Addendum

Reconstruction at
Mahopac High School
Mahopac Middle School
Mahopac Falls School
Bus Garage
New Pump House

BID Addendum No. 3 to Drawings and Project Manual

February 22, 2021

Electrical Site Demolition
and Layout Plan

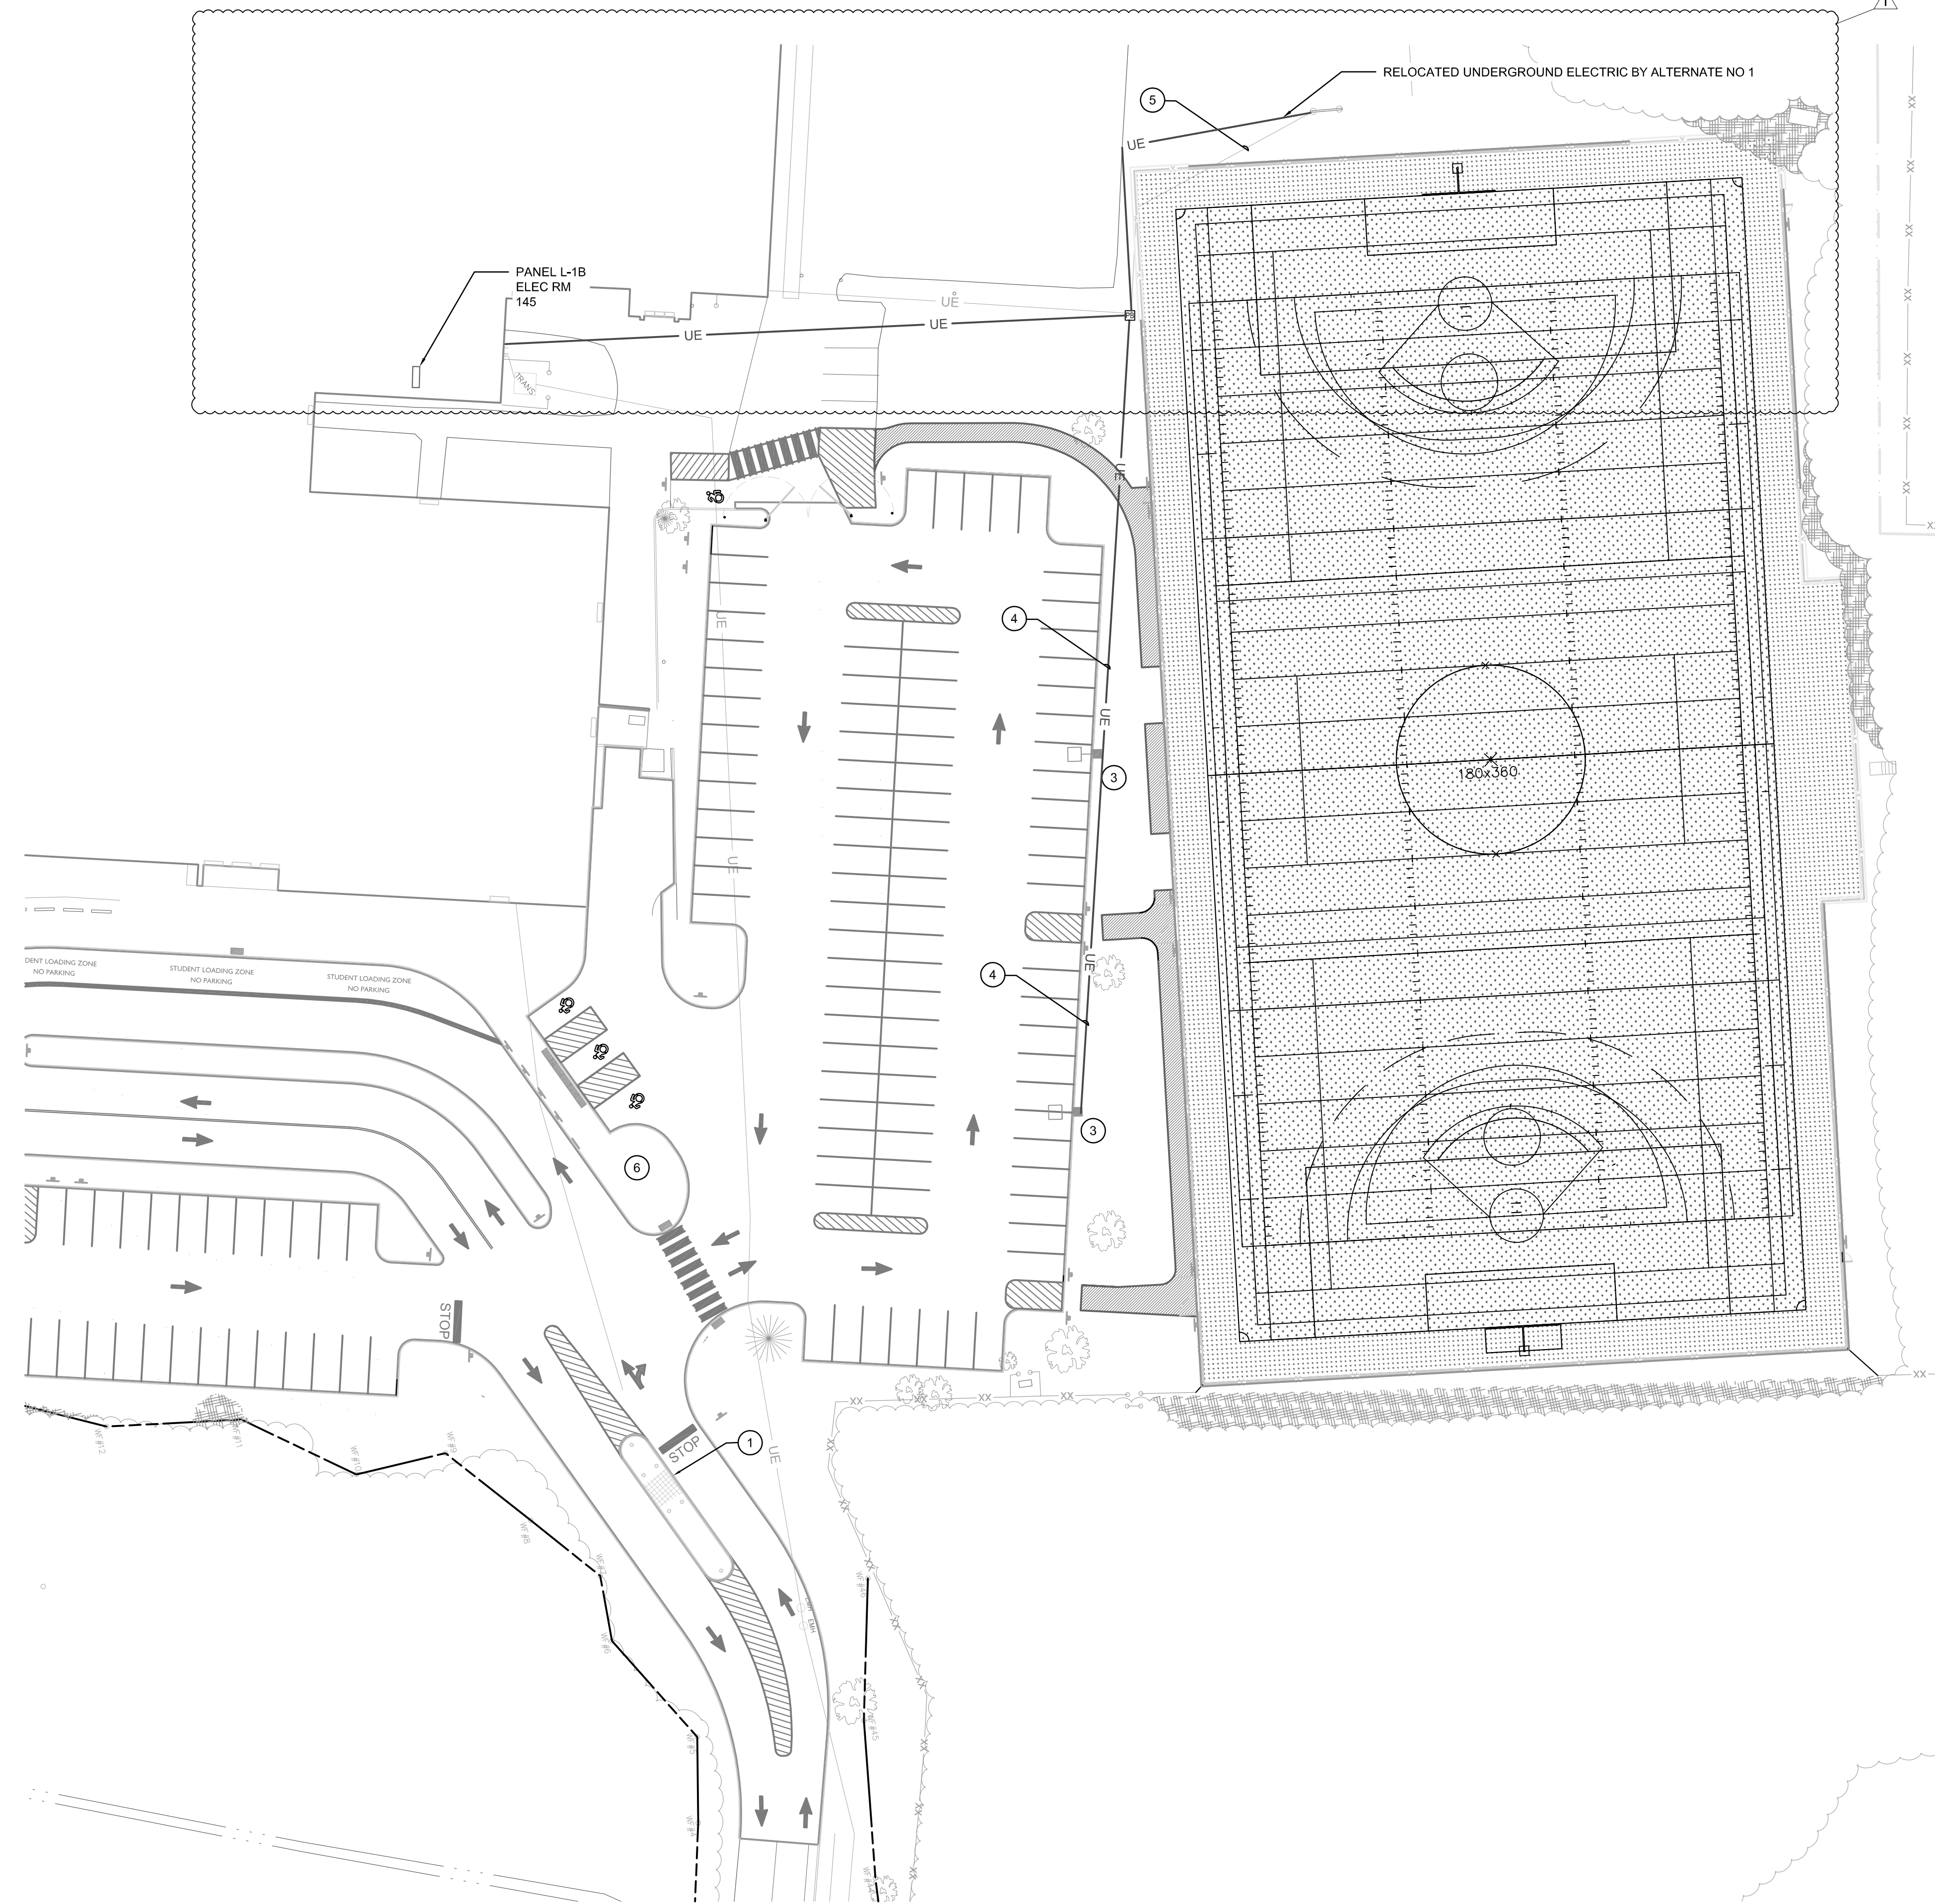
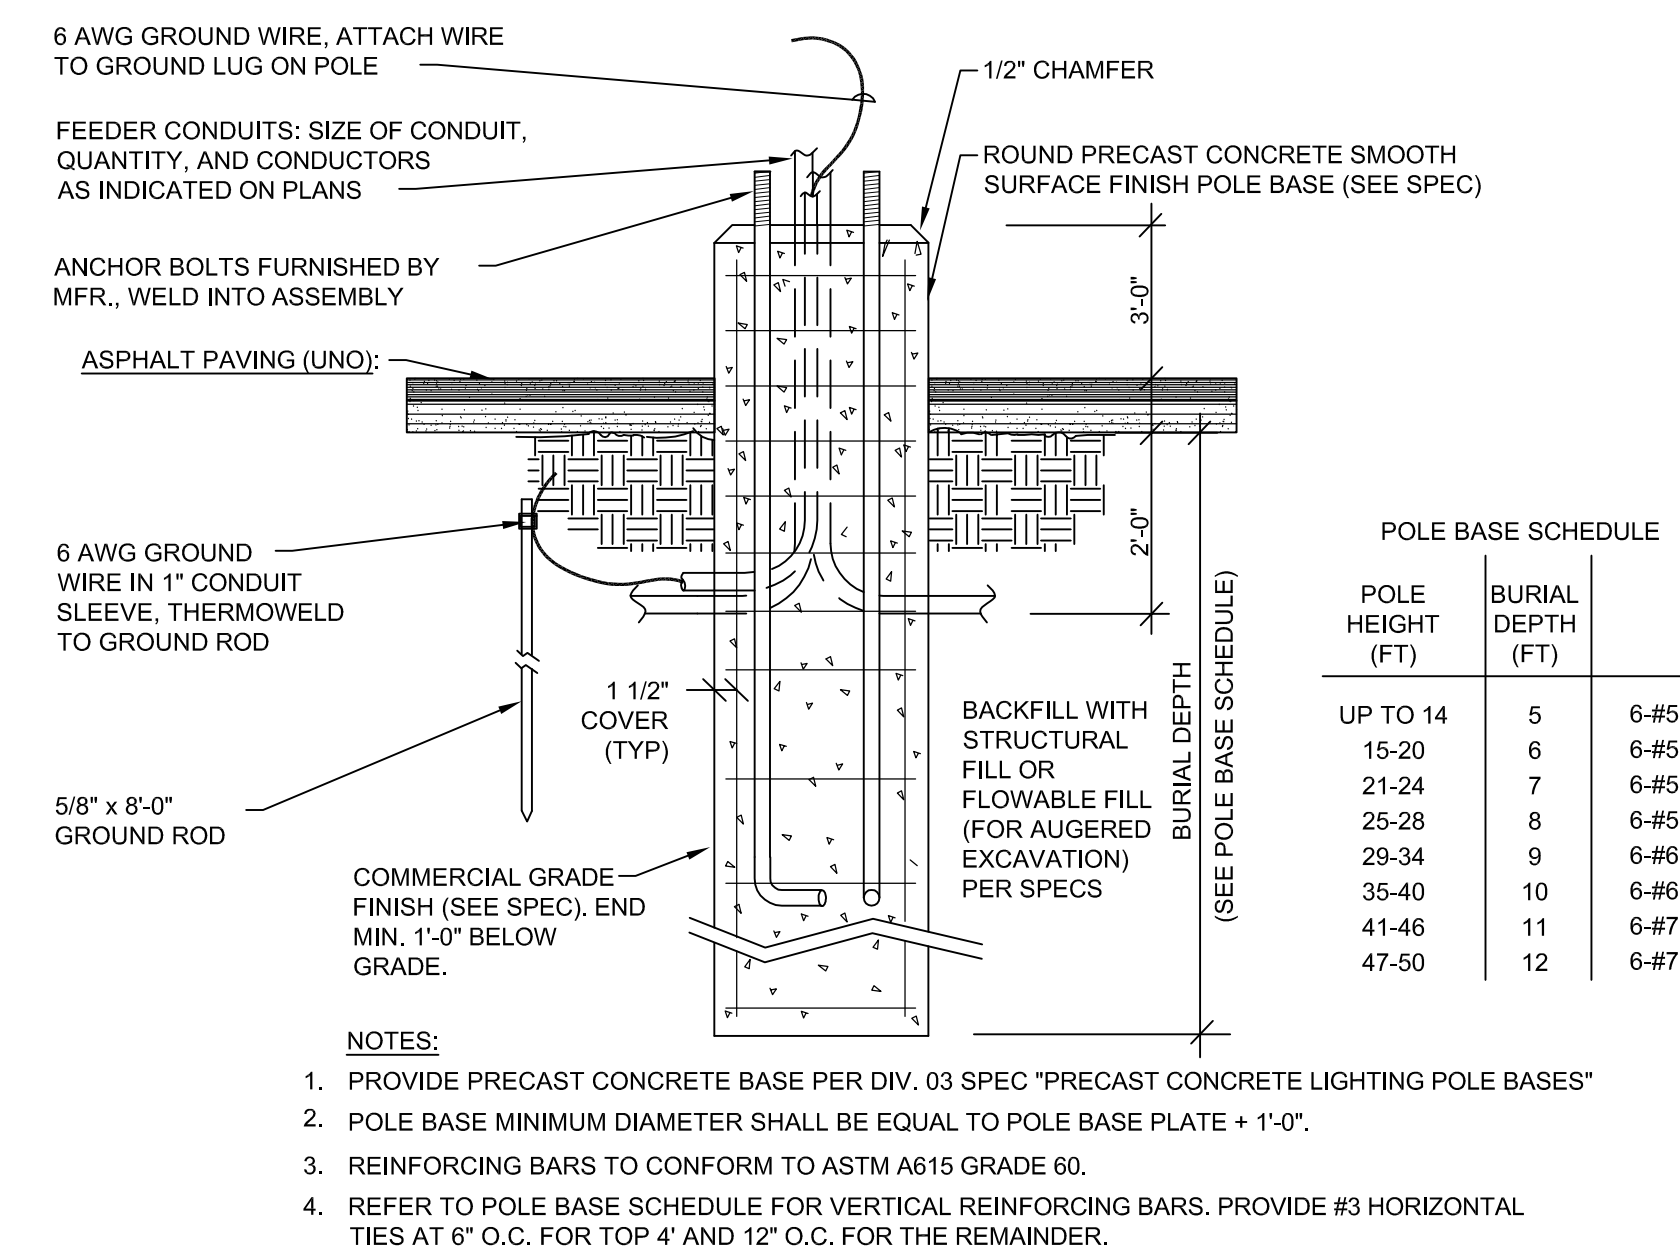
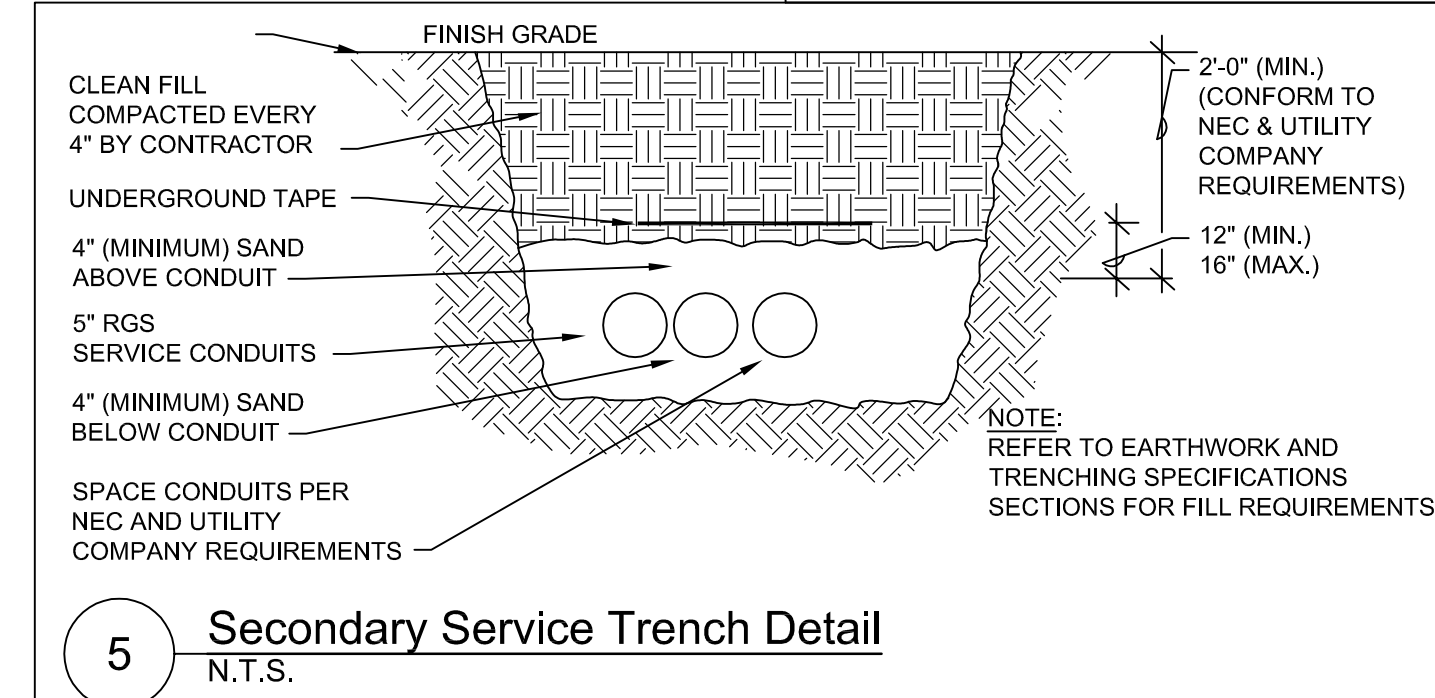
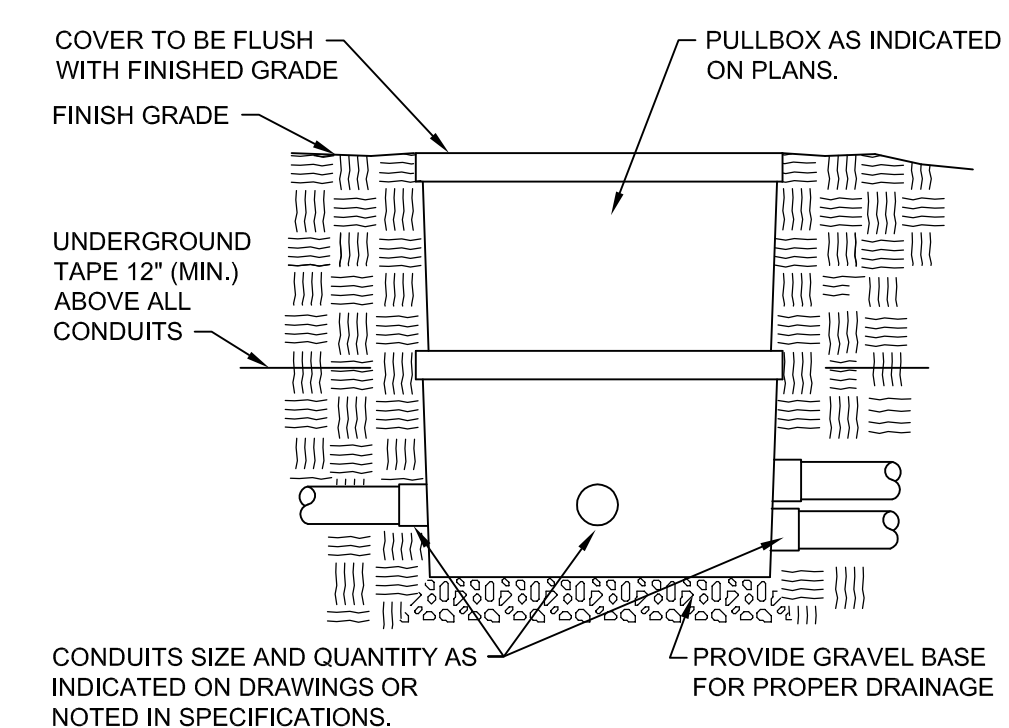
Question: (Please be specific) 1. note 1 on BE001, clarify scope. Where are we extending this existing circuit to and from? noted 2 is not shown on plans for new location. Also provide size of conduit and cable for us to extend?

2. note 3, to what circuit are we wiring the pole receptacles to? to panel L-1B? where is panel L-1B located, plans do not show. Neither does BE160? there is no room 145? please provide location

3. note 4 circuit for new 20' light poles is new pipe and wire correct, there is not existing circuit out there for us to intercept? please clarify/ confirm scope?

4. note 5 for Alternate: can you please clarify the exact scope. where are is the existing circuit that we are relocating to the scoreboard? can you provide old location and new location, feeder size so we know what we are relocating and possibly extending?

Question: (Please be specific) 1. spec bid form list the athletic field as the alternate, but drawing BE001 note 5 only list the relocation of circuit as the alternate. Please clarify what scope of work goes in the Alternate, just note 5 scope or the entire BE001 Athletic field scope of work shown?

1. REFER TO BID ADDENDUM NO 3
2. REFER TO BID ADDENDUM NO 3
3. CONFIRMED, NEW CONDUIT AND WIRE.
4. REFER TO BID ADDENDUM NO 3
5. CONFIRMED, REFER TO BC DRAWING.

ALTERNATE ON BE001 IS NOTE 5 ONLY. REFER TO BC PLANS FOR ATHLETIC FIELD ALTERNATES.
